Product Change Notice (PCN)

PCN Number: PCN-0381131R-01

- CLS0501M
- CLS0501M-L152

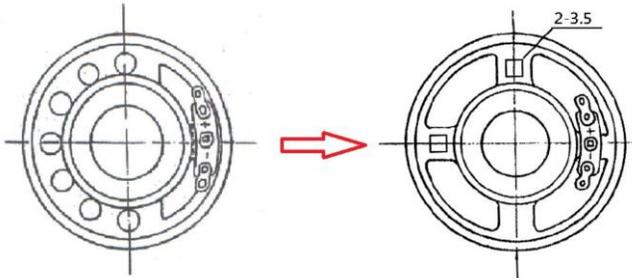
- SPL increased from 80dB to 84dB
- Frame shape has changed (Image Below)

- Tooling plate outdated upgraded
